FOOD STORE
AURORA

REGINA SK

DRAWING:
FLOOR FINISHES PLAN

DRAWING NUMBER: F3.2

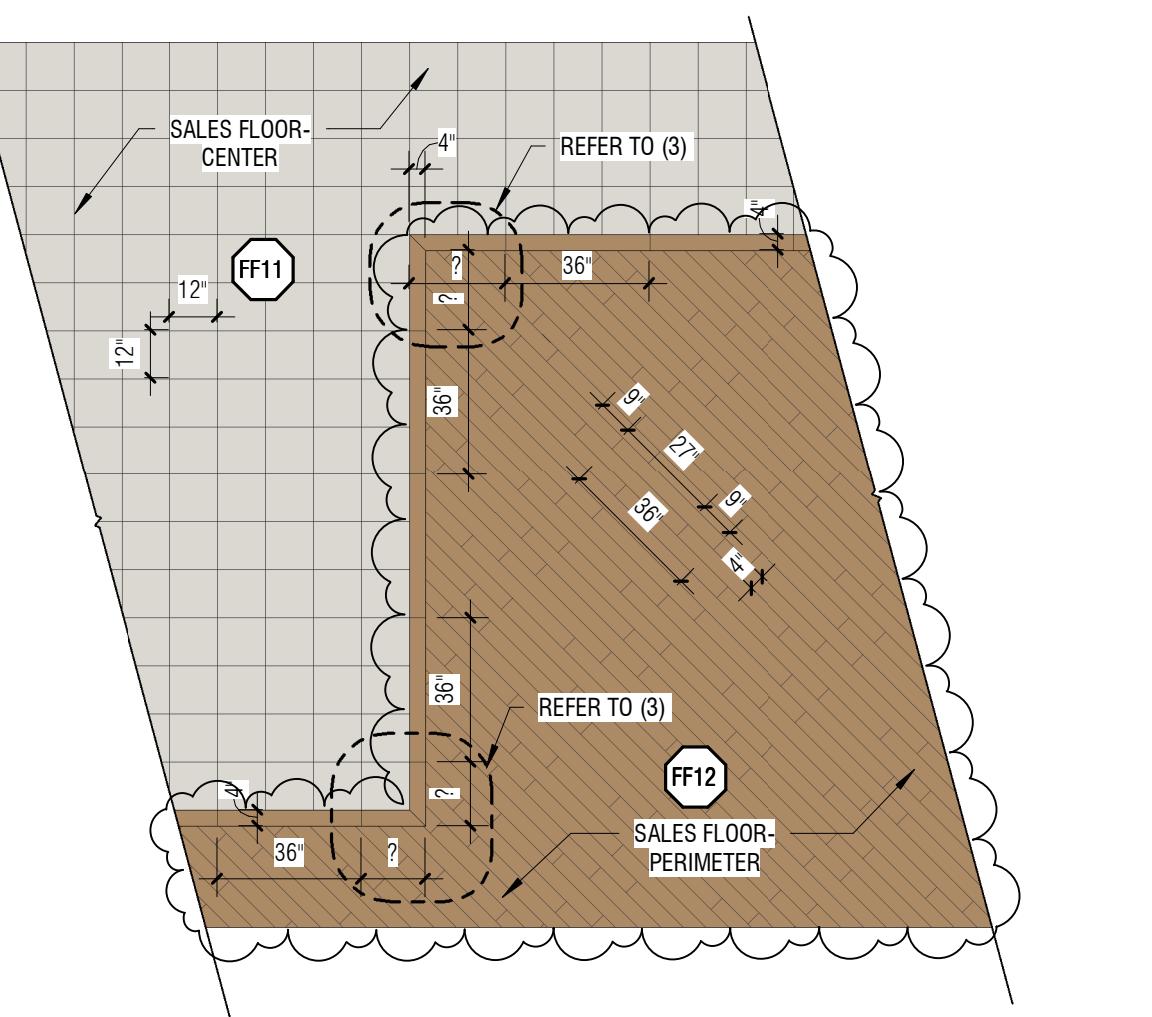
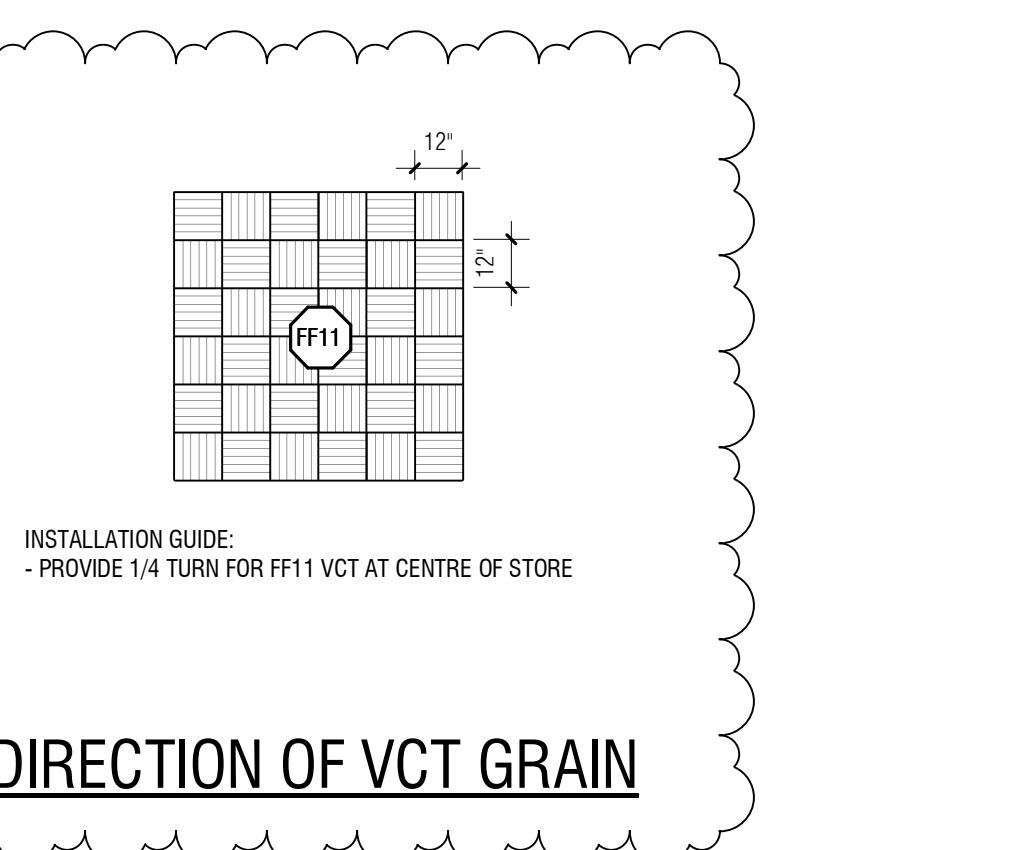
1 REMOVE FF5 FLOORING UNDER Ovens. ADD FF5 FLOORING AT STAIRCASE ADD FF5 TACTILE WARNING STRIP AT MEZZANINE STAIRCASE. ADD FF11 VCT INSTALLATION NOTES. UPDATE FF12 FLOORING GRAPHICS AND DETAIL TO SUIT 1/2 STEP. UPDATE VCT FLOORING NOTE.
